**From:** [Summersgill, Kathleen](#)  
**To:** [Jeremiah Diamond](#)  
**Cc:** [Kahan, Jeffrey](#); [Jennifer Roth](#)  
**Subject:** RE: 950 Greene- Administrative Amendment - Response to Comments  
**Date:** Friday, March 01, 2019 10:23:19 AM  
**Attachments:** [image001.png](#)

**Subject:** 950 Greene- Administrative Amendment - Response to Comments

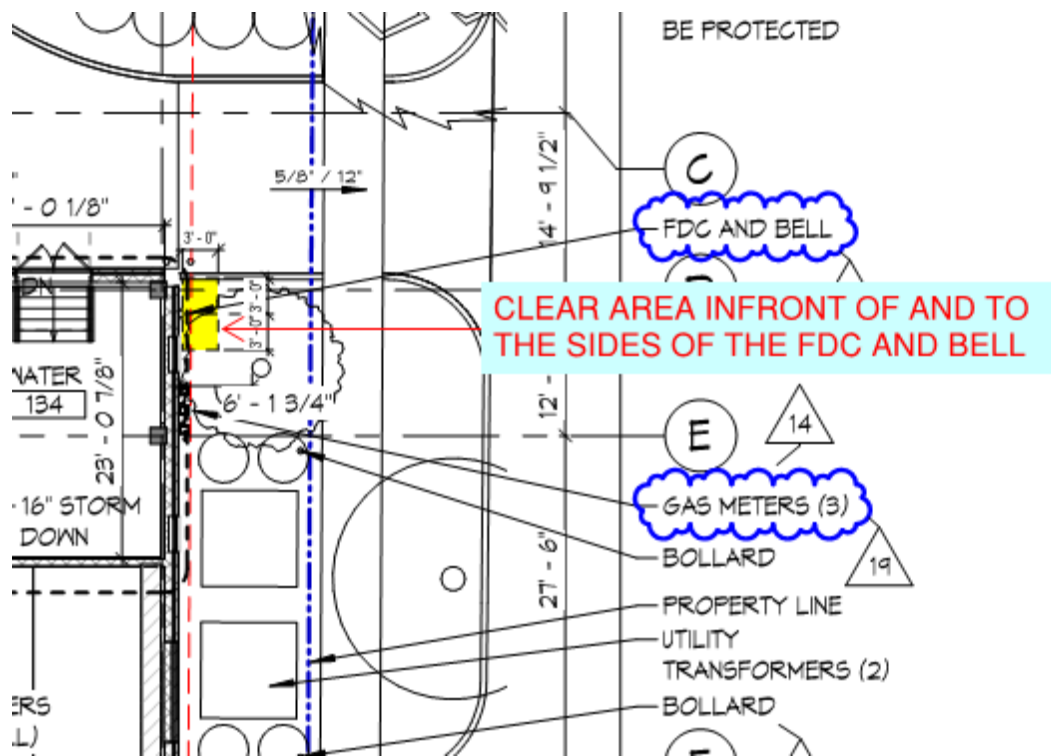
That view shows where the FDC is, however, not what is in between the FDC and the road. Landscaping, transformers, etc. and whatever. I attached a snip of the site plan to see what I am looking at.

**“Verify that there is a clear access to the FDC with a 3' space in front of and to the sides of the connections”.**

OK, thanks for clarifying. This will satisfy my comment.

I want to confirm we have the requested clearances in front of the FDC. It is directly adjacent to the paved driveway. See attached site plan where I added a clearance box and dimensions. This image is from the attached PDF.

It is shown on FP300 in the building permit set.

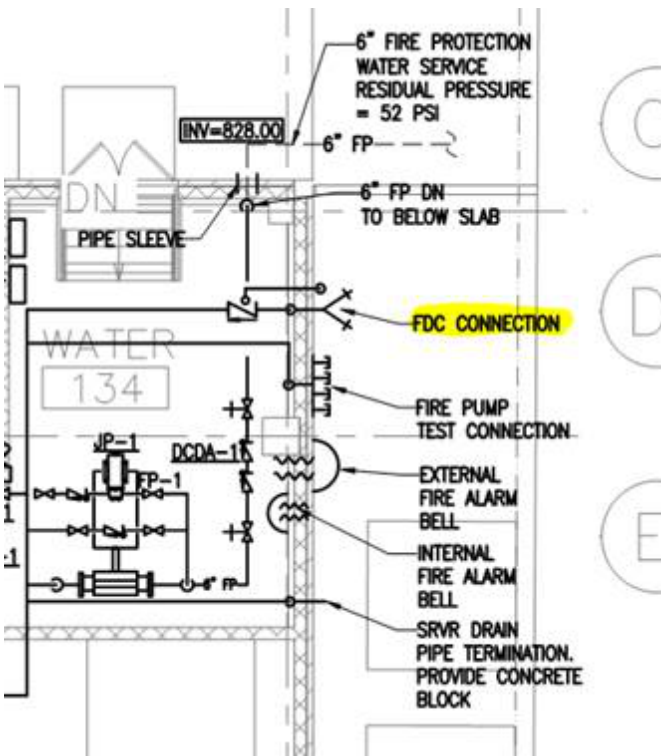
Are you OK with what the petitioner is showing (below)?
